Rebuttal of Susan Tilbrook's Proof of Evidence

Transport and Works Act 1992: Application for the proposed Network Rail (Essex and Others Level Crossing Reduction) Order.

Network Rail (NR) Crossing Ref: E29
DTLR Ref: OBJ/105

Iceni Projects Limited on behalf of I²
Development Management

Figure 7.1 illustrates what various carriageway widths can accommodate. They are not necessarily recommendations.

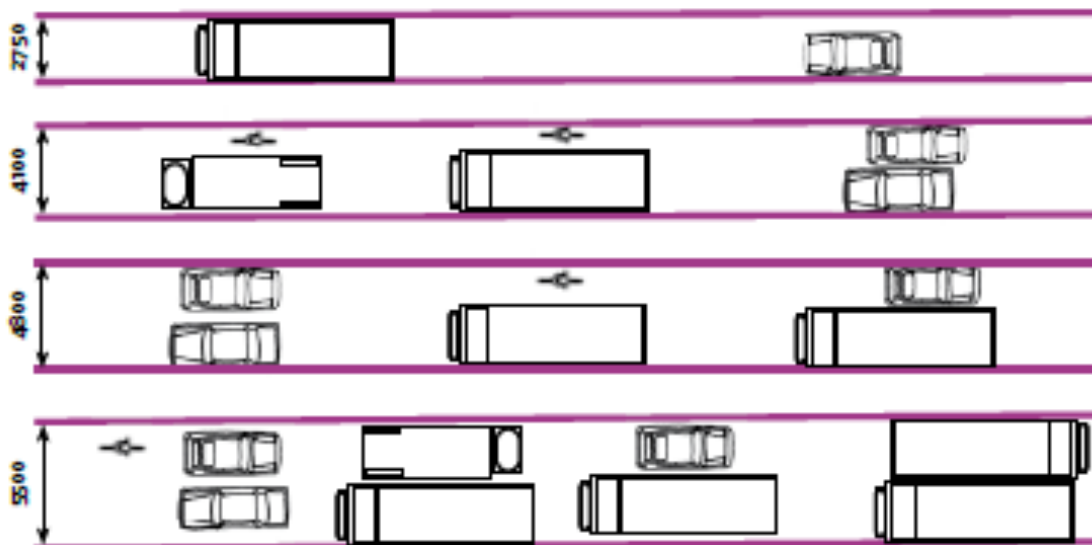
- 2.5. Manual for Streets (page 79, figure 7.1) provides guidance as to the width required for vehicles to pass. For ease of the inquiry I have provided a copy of this figure below:

- 2.6. As can be seen a width of 4.8m barely allows an HGV and car to pass, with no space for pedestrians. Given the presence of an operational industrial estate and employees travelling too and from work, this situation is likely to occur a number of times throughout the day. Furthermore , 4.8m would not accommodate two cars and a pedestrian. It is however very apparent that 5.9m would accommodate two-way traffic with a pedestrian, especially given the slower vehicle speeds and the benefit of an additional narrow strip of vegetation. For clarity Manual for Streets only shows up to 5.5m and not the 5.9m available.
